# **FINAL NON TIME-CRITICAL REMOVAL ACTION WORK PLAN FOR RVAAP-34 SAND CREEK DISPOSAL ROAD LANDFILL**

## **FORMER RAVENNA ARMY AMMUNITION PLANT PORTAGE AND TRUMBULL COUNTIES, OH**

**Document:** Draft Non Time-Critical Removal Action Work Plan for Sand Creek Disposal Road Landfill (RVAAP-34).

**Reviewer(s):** Kevin Palombo, Environmental Specialist, Ohio EPA

### **Comment 1: Section 1.0: Introduction, Figure 1.4, Estimated Extent of Soil Remediation**

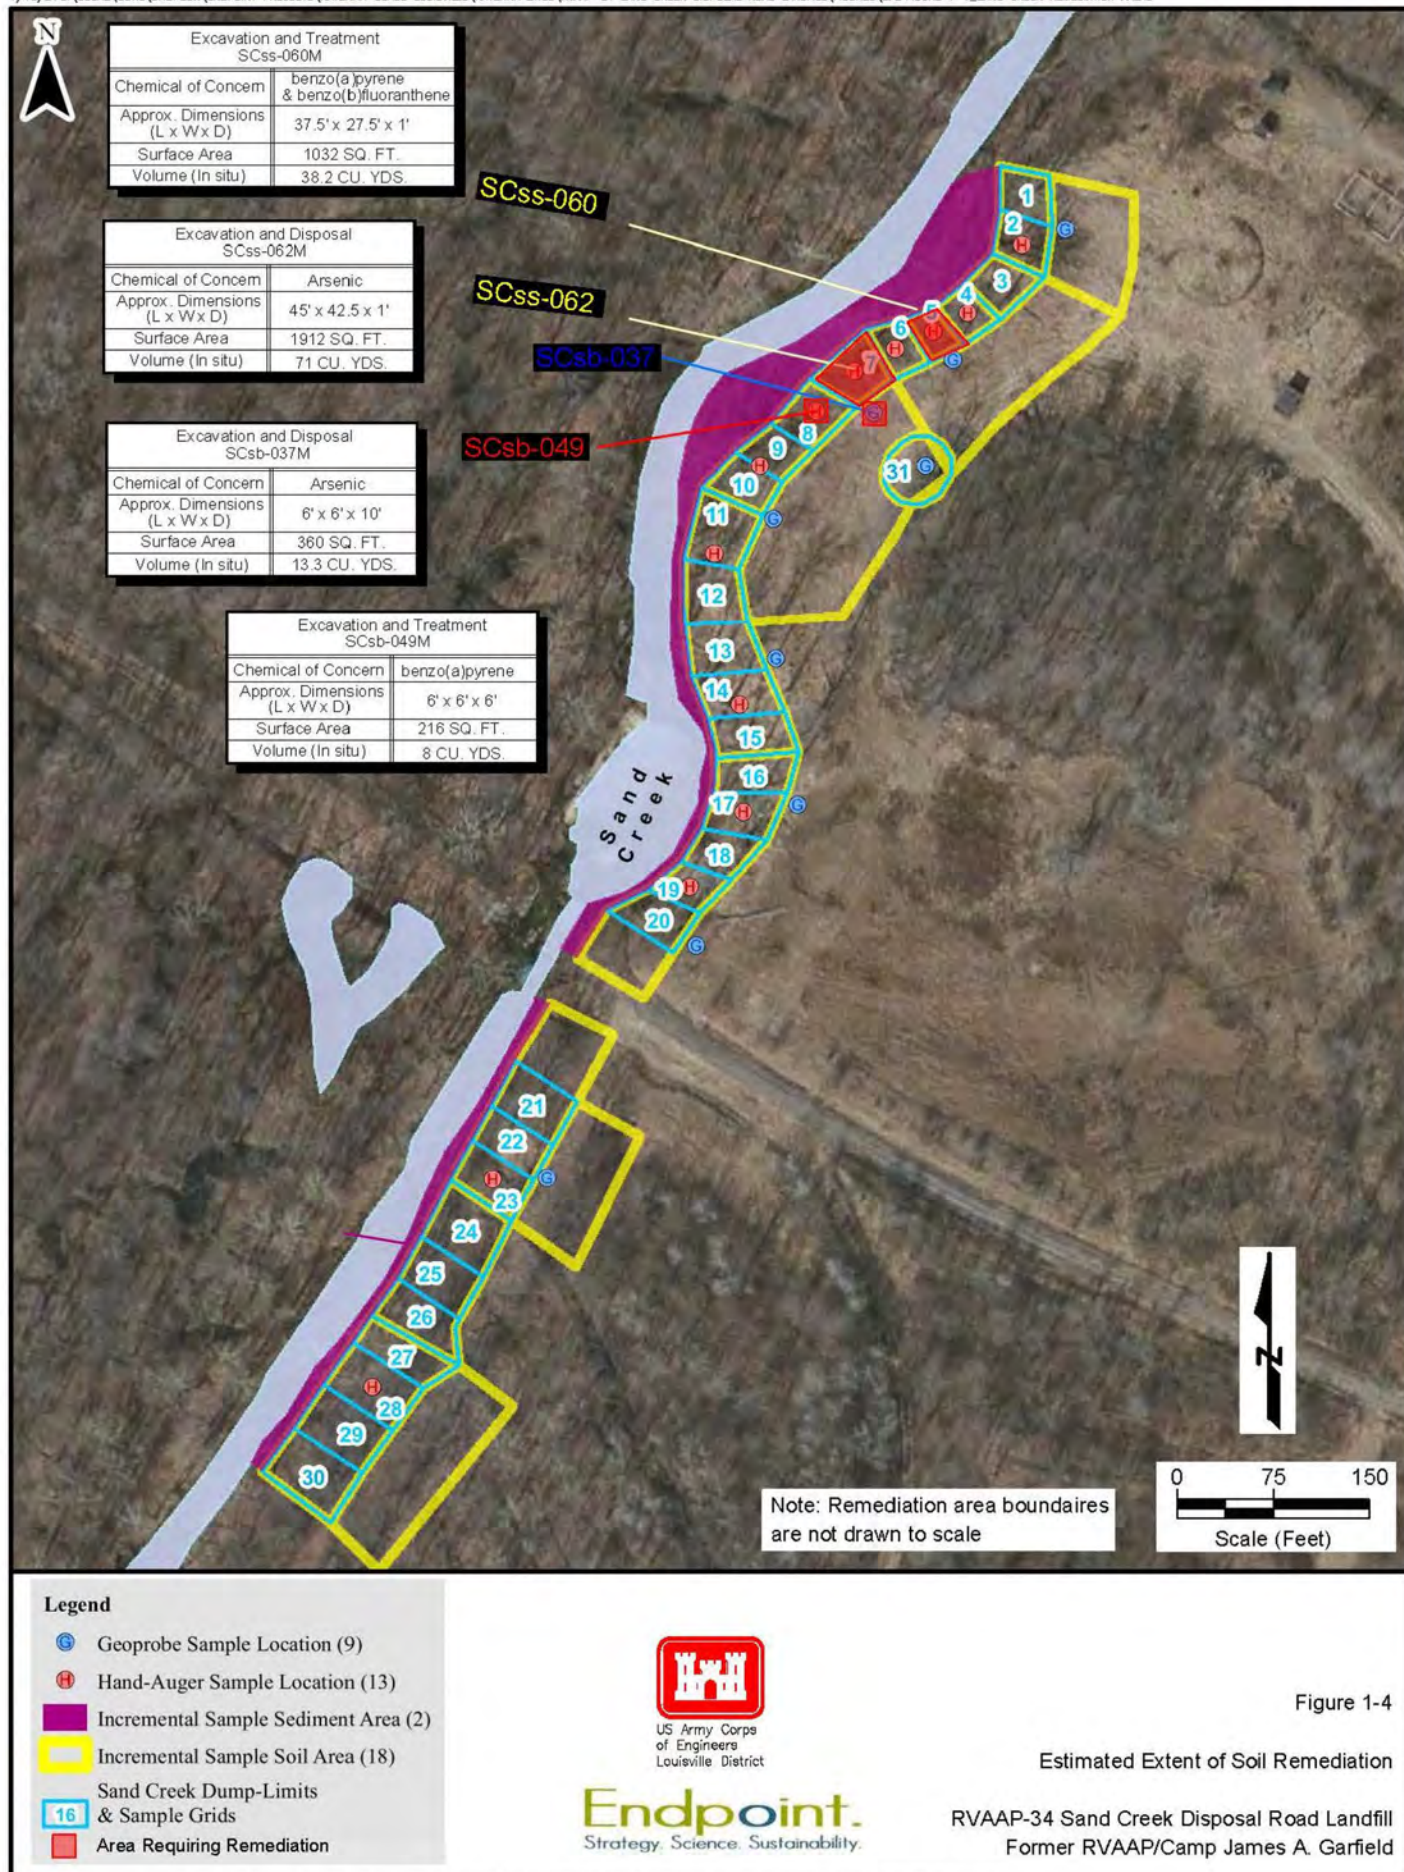
<b>Cmt. No.</b>	<b>Page or Sheet</b>	<b>Comment and Recommendation</b>	<b>Response</b>
Ohio EPA 1	Figure 1.4	<p>The identification labels for areas SCsb-037M, and SCsb-049M are illegible.</p> <p><u>Action Item:</u> Revise the map and modify area identifying labels.</p>	<p>Figure 1.4 has been revised so that the referenced labels are legible. See attached copy of the revised figure.</p>
Ohio EPA 2	Section 5.2.2, Page 23	<p>A description of the thermal treatment process is described in this section, but the volume or thickness of the soil in the treatment chamber is not provided. The section also explains that the temperature in the chamber reaches 500-700 degrees Fahrenheit. It is unclear if the soil temperature is specifically monitored or just the temperature within the chamber.</p> <p><u>Action Item:</u> Clarify the what the volume (and thickness) of the soil is within the chamber and specifically if the temperature of the middle of the soil volume is monitored.</p>	<p>The following sentences in the second paragraph under “VEG Thermal Treatment Process” in Section 5.2.2. have been revised to read:</p> <p>“The steam created through the VEG’s vapor generator is in turn placed into contact with the impacted soil within a fully enclosed and sealed treatment chamber. Depth of soil within the treatment chamber is approximately 2.5 feet.”</p> <p>“Soil temperatures will be measured after the soil is discharged from the treatment chamber by inserting thermocouples in the soil, or using a hand-held infrared thermometer, demonstrating that soil has reached target treatment temperatures.”</p>

**Response to Comment:** Figure 1.4 has been revised so that the referenced labels are legible. A copy of the revised figure was also attached. **The response addresses the comment.**
